API WELL #	Well Name	Well #	Operator Name	Type	Stat	County	Surf_Owner	UL	Sec	Twp	N/S	Rng	W/E
30-045-22034-00-00	NAVAJO L 12	006	CHEVRON MIDCONTINENT, L.P.	G	A	San Juan	I	L	12	25	N	11	W

SUNDRY NOTICES AND REPORTS ON WELLS
Do not use this form for proposals to drill or to re-enter an abandoned well. Use form 3160-3 (APD) for such proposals.

CHEVRON MIDCONTINENT L.P. RESPECTFULLY REQUESTS APPROVAL FOR AN EXCEPTION TO NMOCD RULE 19.15.12.9 TO PERMIT DOWNHOLE COMMINGLE FROM THE BASIN DAKOTA (71599) AND THE BASIN MANCOS (97232) IN THE NAVAJO L 12 #6. BOTH POOLS ARE IN THE PRE-APPROVED NMOCD POOLS COMBINATIONS LIST FOR DHC IN THE SAN JUAN BASIN PER ORDER R-12984-A. A DHC WILL OFFER ECONOMICAL METHOD OF PRODUCING WHILE PROTECTING AGAINST RESERVOIR DAMAGE, WASTE OF RESERVES & VIOLATION OF CORRELATIVE RIGHTS. OWNERSHIP IS COMMON IN BOTH ZONES; THEREFORE THERE ARE NO OWNERS TO NOTIFY OF OUR INTENT TO DHC.

Navajo L12-6

San Juan County, New Mexico
Proposed Schematic as of June 2014

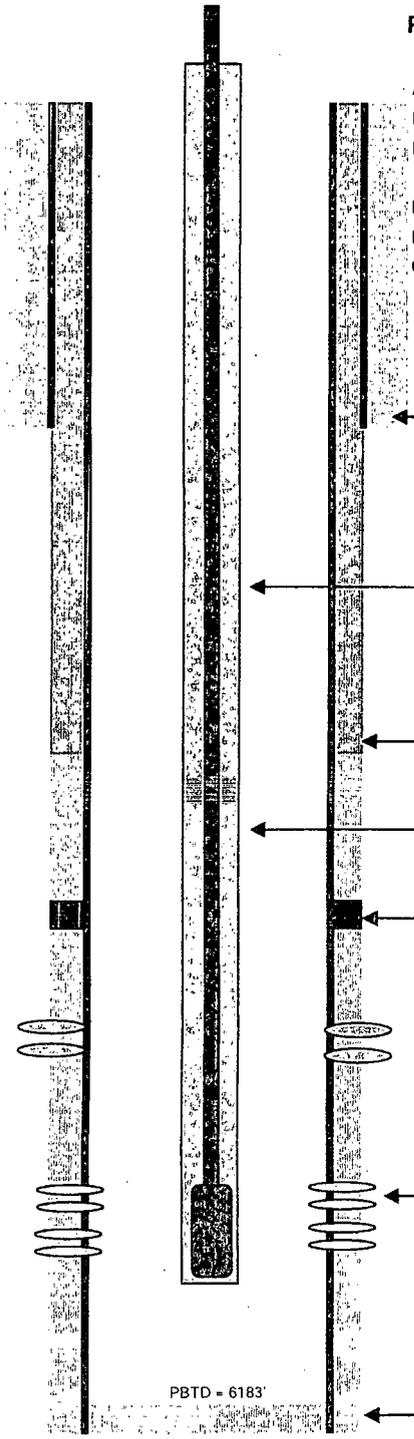
No Current Wellbore Diagram in Attachments only this Proposed
